Subj: Northeast Nuclear Energy Company
(Millstone Station, Unit 3),
Docket 50-423-LA

Millstone Nuclear Power Station Unit No. 3
Response to Notice Request for Information
On The Recirculation Spray System

MP3 - RSS SYSTEM; RESPONSE TO NRC INFORMATION REQUEST DATED FEBRUARY 3, 1998

FIGURE 3
RSS SYSTEM SCHEMATIC SHOWING LOCATION
OF MAJOR DESIGN MODIFICATIONS.
 (ONLY ONE OF FOUR RSS PUMP/HX FLOW PATHS SHOWN)

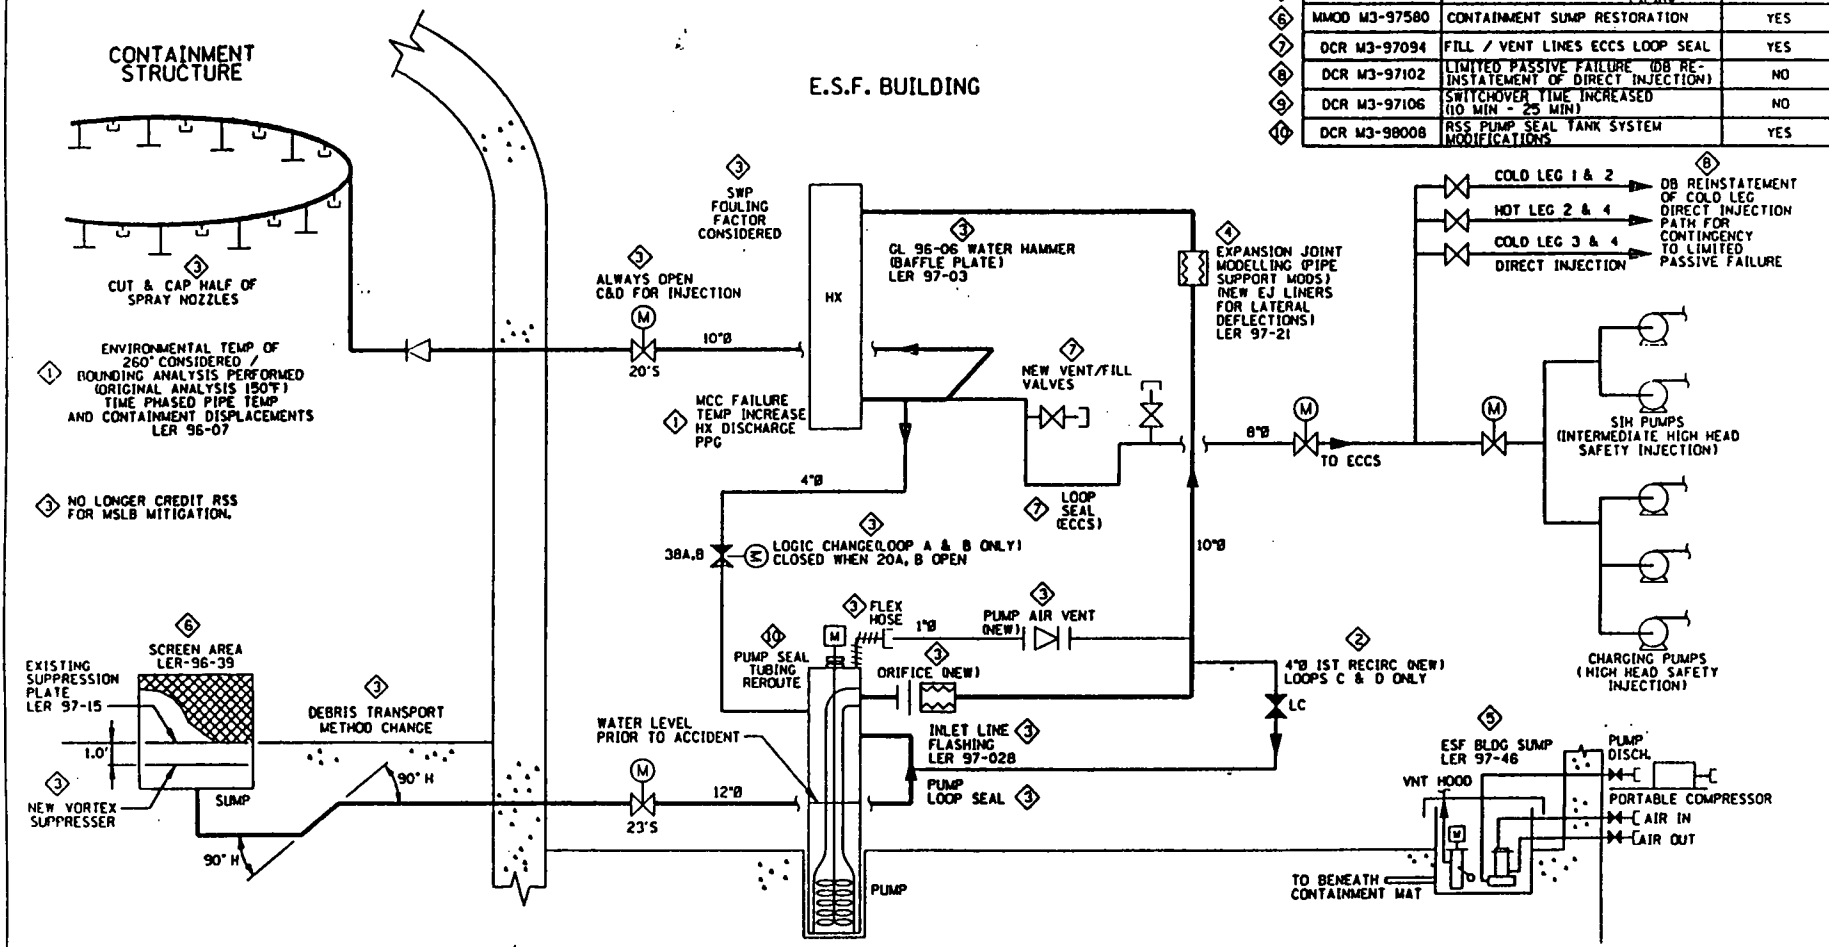
The Cold Leg Recirculation Phase operation of the system in 1998 is similar to the original 1985 alignment with two substantial changes. First the RSS pumps are not isolated from the containment spray header when they are aligned to supply ECCS cooling. These pumps will provide a dual function: ECCS injection, as well as, containment spray function. Second, the direct injection paths from the RSS pumps to the RCS cold legs are isolated to prevent direct injection to prevent tube vibration. The direct injection flow path remains available as a contingency action in the event that charging and SIH become unavailable. This alignment is depicted in Figure 2B and is controlled by the EOPs.

The Hot Leg Recirculation Phase operation of the system in the 1998 configuration differs from the original 1985 alignment in that 1) the RSS pumps are not isolated from the containment spray header when they are aligned to supply ECCS cooling, and 2) the direct injection path from the RSS pumps to the RCS hot leg is not opened. The 1998 flow paths are shown in Figure 2C.

The direct injection paths of the RSS pumps to the cold legs are available to the operators as contingencies for mitigating situations in which at least one SIH and one charging pump are not available (Figure 2C). These situations could arise either as a result of multiple failures or from isolating certain limited passive failures in the ECCS. The use of these contingencies are controlled by the EOPs.

FIGURE 6
VORTEX SUPPRESSION PLATE DESIGN
AND RSS PUMP LAYOUT
 (B & D PUMPS SHOWN)

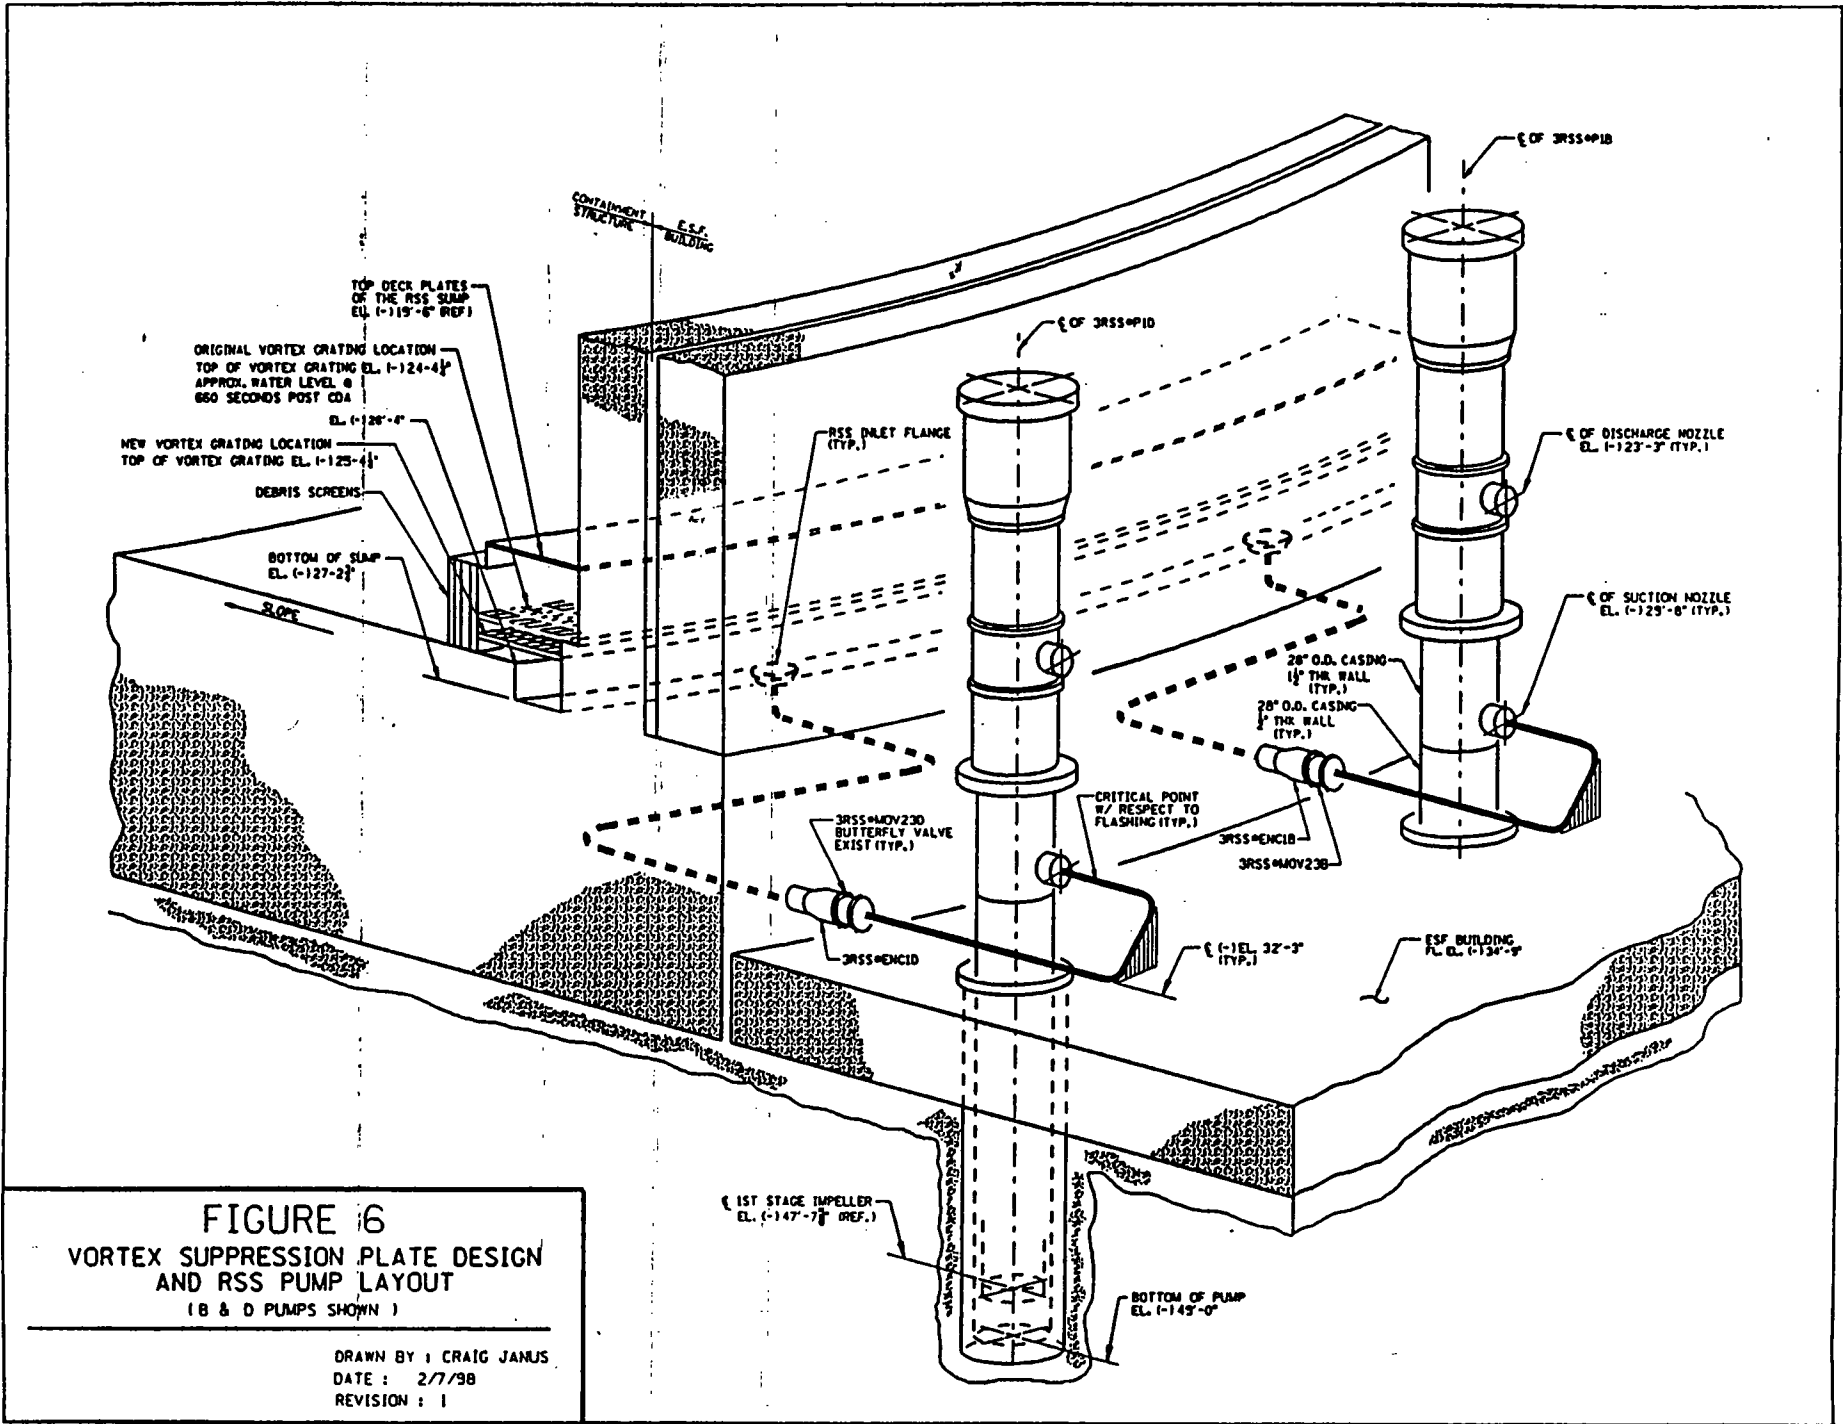
It was determined that the existing vortex suppresser was inadequate and that it needed to be lowered 12 inches (see Figure 6). The new location does not invalidate the results of the tests performed by Alden Research Laboratory which originally qualified the device as capable of preventing vortices under the most adverse conditions expected in the sump. The basic design is unchanged. In addition, the sump geometric layout with the new vortex suppressor is consistent with the design recommendations of NUREG 0897, Revision 1.

FIGURE 7
RSS SYSTEM FLOW TEST VIBRATION
MONITORING POINTS

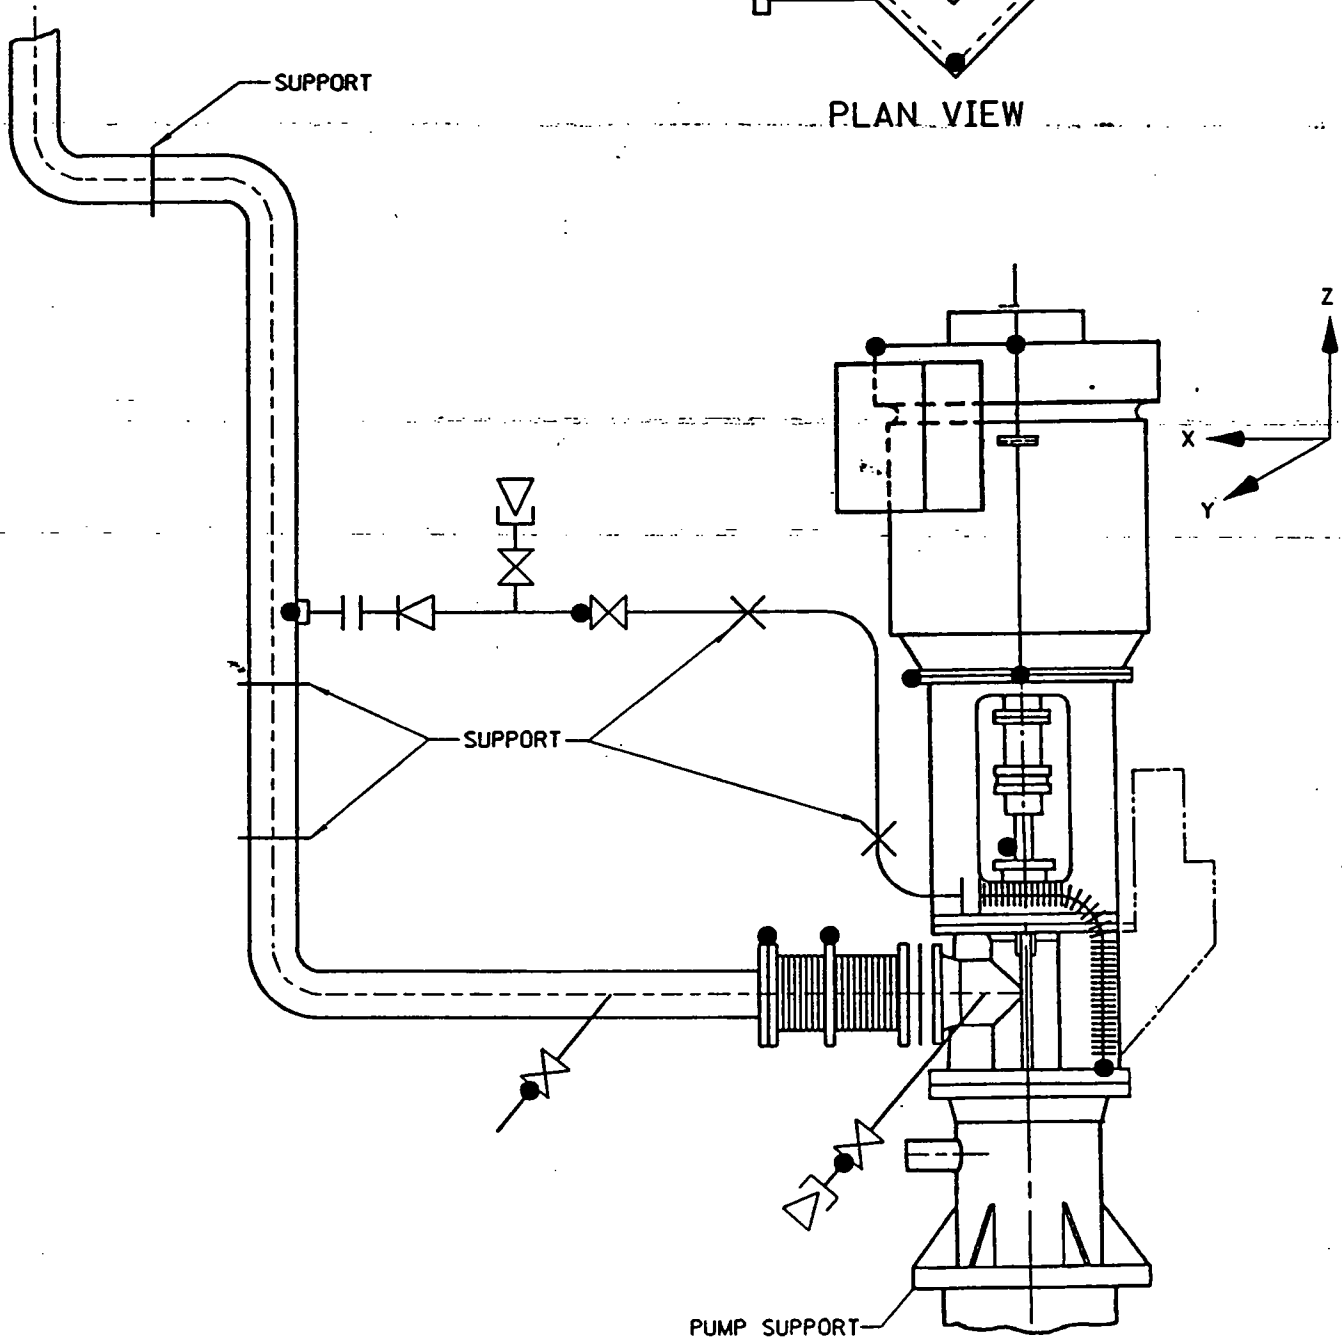
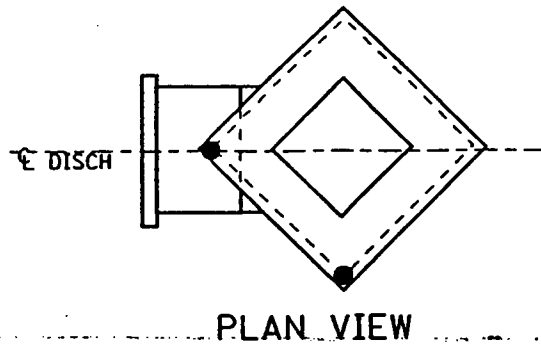
Initial vibration test results have been obtained for the B and D RSS pumps. (Refer to Figure 7 for RSS system flow test vibration monitoring points). The data indicates no significant changes in pump/motor vibration and overall vibration amplitudes remain well within acceptable limits. The pump shaft vibration amplitudes did not change, indicating that the pump mechanical seal and bearings are unaffected. Vibration levels on the motor frame have increased due to flow induced vibration from the orifice plates. The flow induced vibration is seen in the vibration spectrum as increased amplitudes at the motor/ pump structural natural frequencies and an increase in the noise floor. There have been no significant changes at the vibration frequencies which could impact the operation of the pumps or motors. The changes due to the flow induced vibration are of little consequence because of the low amplitudes, and the fact that the motor rotor and frame move together at the structural natural frequencies. This type of vibratory motion contributes very little to the limiting factors of bearing loading and rotor deflection relative to the stator.
